## Bayside Planning Panel

Item No	<b>6.1</b>
Application Type	Development Application – Mixed Use Development (Boarding House and Commercial Building)
Application Number	DA-2016/125
Lodgement Date	1 August 2016
Property	<b>1094-1098 Botany Road, Botany</b> (Lots 43, 44 & 45 in DP 856900)
Owner	Frank & Pauline Malouf and FOLAM Pty Ltd
Applicant	Mario Khaicy
Proposal	Redevelopment of heritage item, ' <i>Finnies Building</i> ', including demolition of the rear wings for the addition of a four (4) storey building for a 35 room boarding house (including a caretaker's unit), with four (4) ground floor retail premises and 12 car parking spaces and land remediation.
No. of Submissions	Nil
Cost of Development	\$4,312,390.00
Report by	Kim Johnston, Consultant Planner

## Planning Assessment Report

<b>Application Number:</b>	2016/125
<b>Date of Receipt:</b>	1 August 2016
<b>Property:</b>	1094-1098 Botany Road, Botany Lot 43, 44 & 45 DP 856900
<b>Owners:</b>	Frank Malouf, Pauline Malouf and FOLAM Pty Ltd
<b>Applicant:</b>	Mario Khaicy
<b>Proposal:</b>	Redevelopment of a heritage item, 'Finnies Building', including demolition of the rear wings for the addition of a four (4) storey building co

Figure 9: Southern elevation showing mansard roof (Source: Giles Tribe Architects)

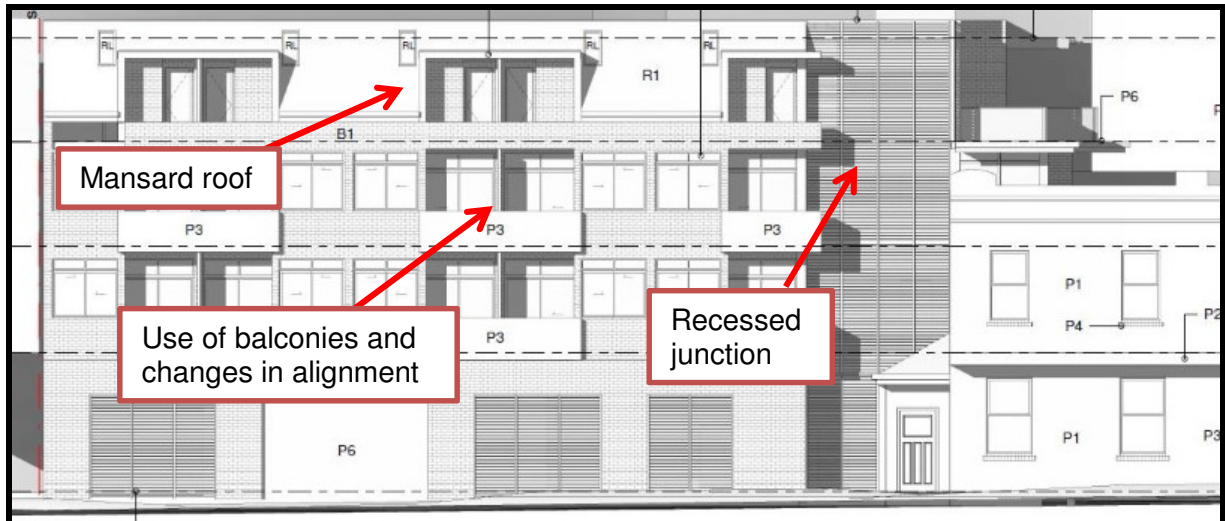
The use of the mansard roof form along the Bay Street frontage (**Figure 9**) gives the building a three storey appearance along this elevation which assists in reducing the bulk and scale of the development when viewed from the street and surrounding area. The use of balconies and other protruding detailing further reduces the bulk and scale and provides visual interest in the street façade.

**Figure 10: Height Exceedance above Development Standard**  
(Source: Giles Tribe Architects)

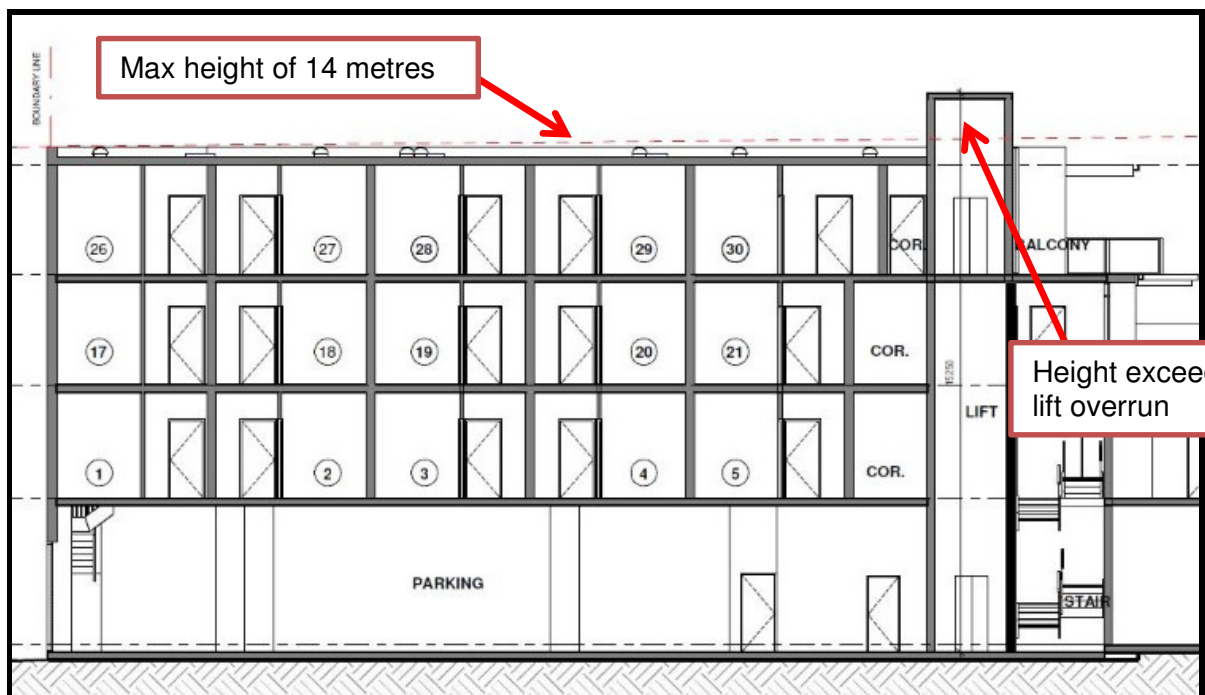
The extent of the height exceedance, to the top of the lift overrun, is **1.25 metres**. The highest point to the building parapet is 14 metres and accordingly, the variation to the height development standard arises from the lift overrun only. This is illustrated in **Figure 10**.

**Figure 2**  
Extract from Sheet DA08 – Elevations (Sheet 2)

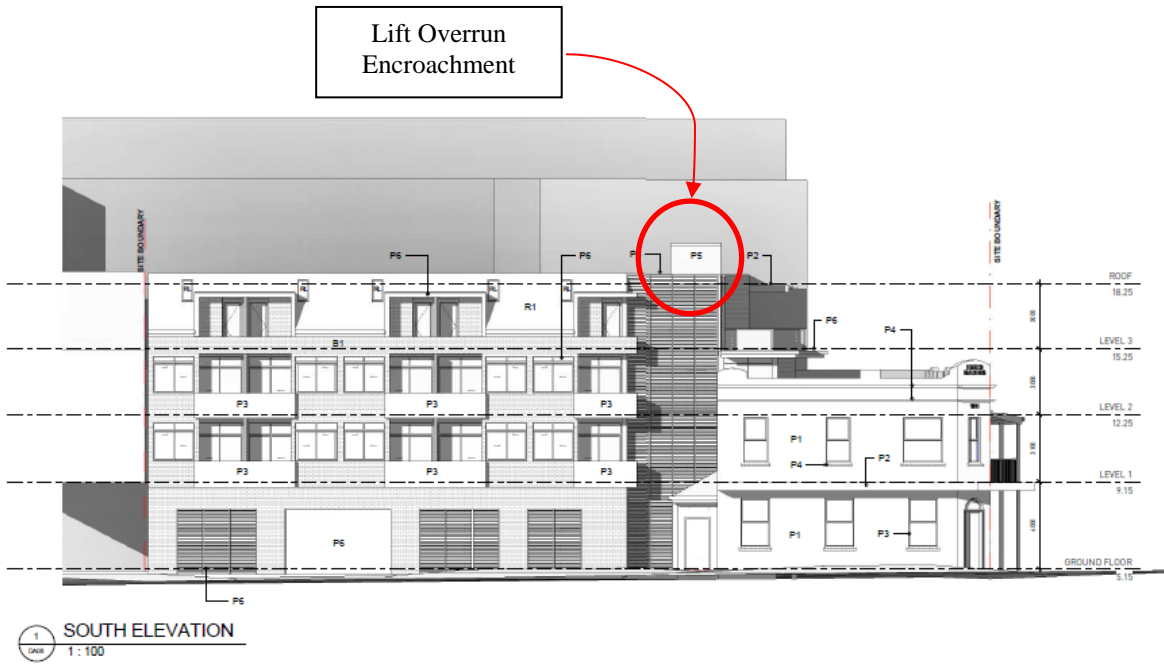
The proposal seeks a building height of 15.25 which is wholly attributable to the lift overrun which is 1.25 metres higher than the maximum permissible building height under the Botany Bay Local Environmental Plan 2013. The extent of the variation to the height controls is shown in **Figure 2** and **Figure 3** with only minor encroachments from the lift overrun through the 14 metre height plane.

**Figure 4**  
**Streetscape Analysis as viewed from Botany Road**

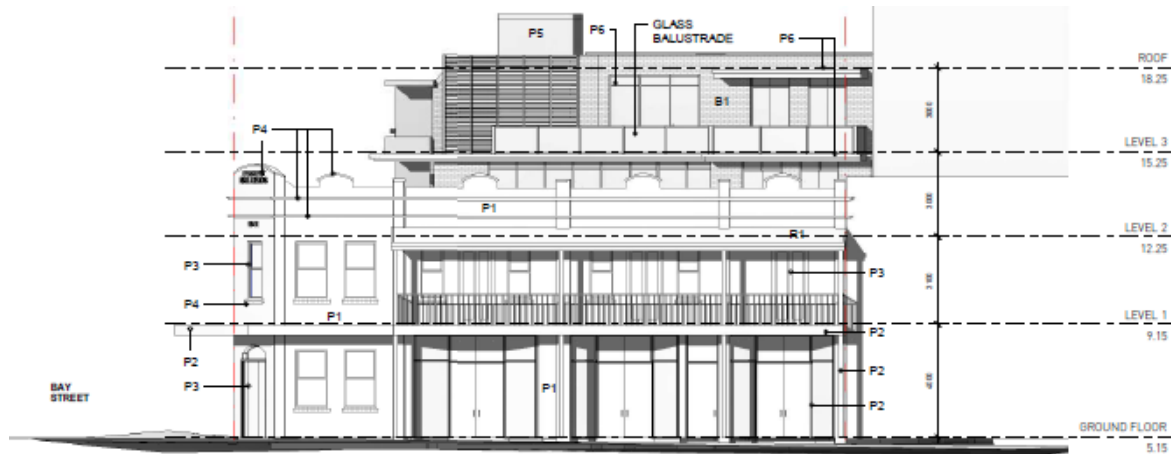
The height variation is considered to be reasonable when considered within the context of the overall streetscape with its primary frontage to Botany Road and the intent of the Botany Bay Local Environmental Plan 2013. The building is four storeys and integrates satisfactorily within the future street context (see *Figure 4*).
